City of Mississauga Department Comments

Date Finalized: 2022-06-15	File(s): A280.22
To: Committee of Adjustment	Ward: 2
From: Committee of Adjustment Coordinator	Meeting date:2022-06-23 1:00:00 PM

Property Address: 1376 Mississauga Rd

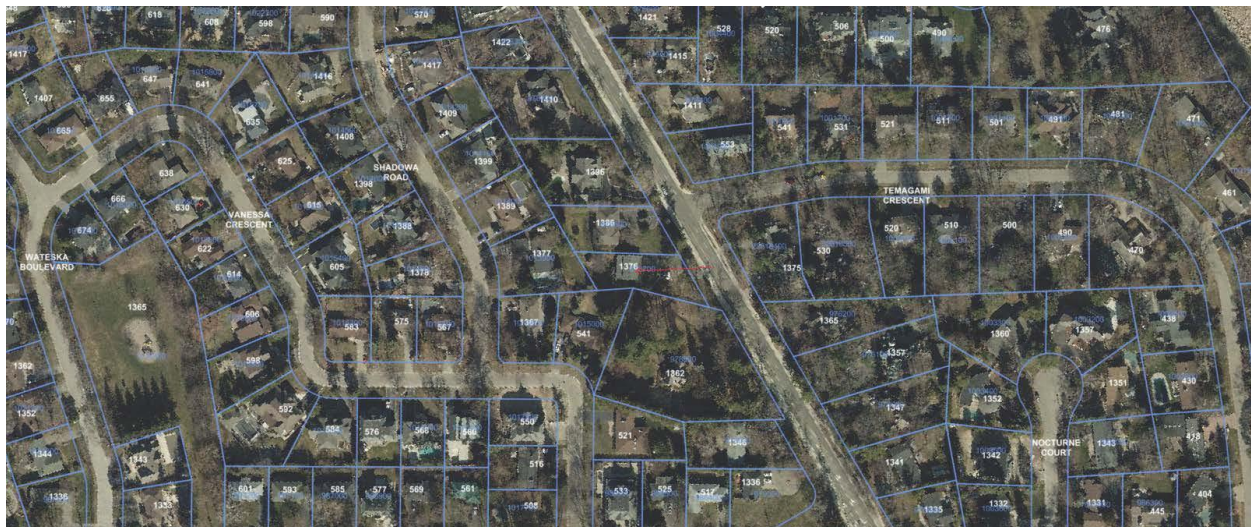
We are noting for Committee's information that any Transportation and Works Department concerns/requirements for the proposed dwelling will be addressed through the future Site Plan Application process. However, this Department does not support variance #4 for the 0m setback for the driveway. As you can see from the pictures attached, the existing driveway turnaround has been constructed partially within the Municipal right of way Mississauga Road. There is also additional hard surface for parking/turn around purposes on the left side of the driveway within the applicant's own lands.

We ask that the municipal boulevard area be reinstated with topsoil and sod and the 2 light posts that are also within the municipal boulevard area be removed.
